CITY PLAN COMMISSION

FILE NUMBER: S245-020

REQUEST: An application to create one 2.811-acre lot from a tract of land containing part of City Block B/7226 on property located on Dallas-Fort Worth Turnpike/ Interstate Highway 30, east of Westmoreland Road.

PRELIMINARY PLAT

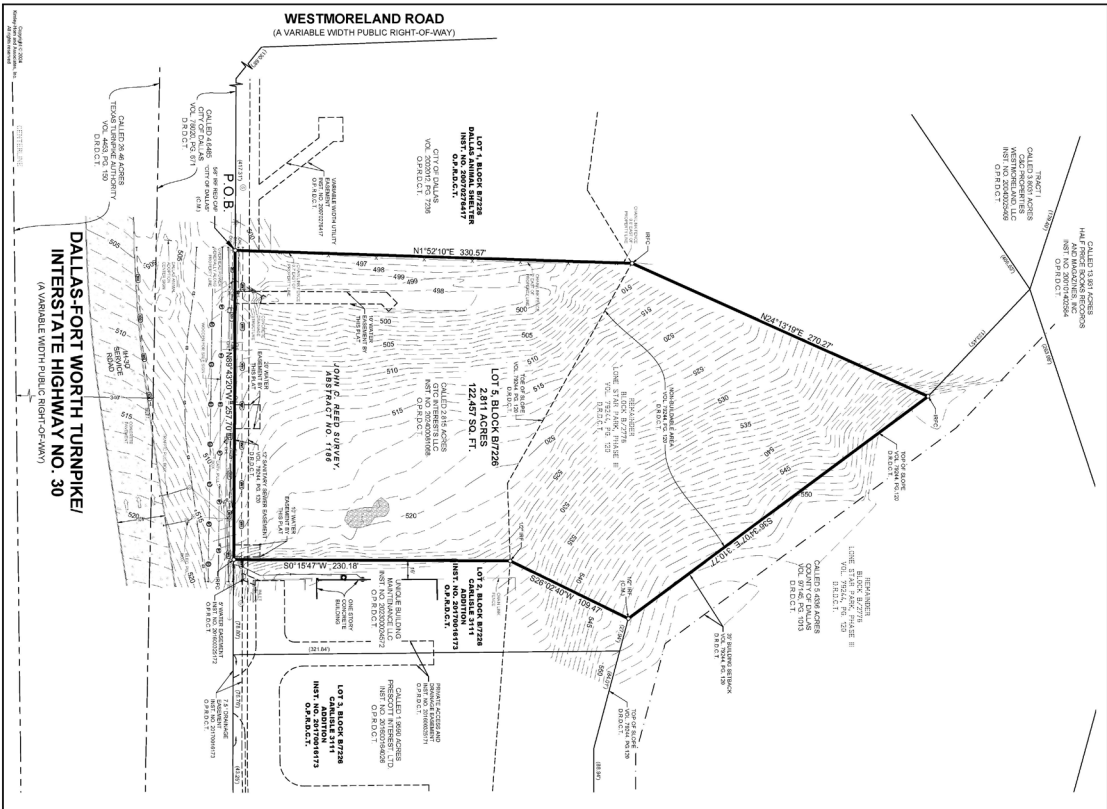
25. Prior to final plat, compliance with City's Street lighting standards including illumination standards, material, installation, and activation per Street Design Manual.
26. On the final plat, change "Westmoreland Road" to "Westmoreland Road (AKA Westmoreland Avenue)". Section 51A-8.403(a)(1)(A)(xii).
27. On the final plat, identify the property as Lot 5 in City Block B/7226.
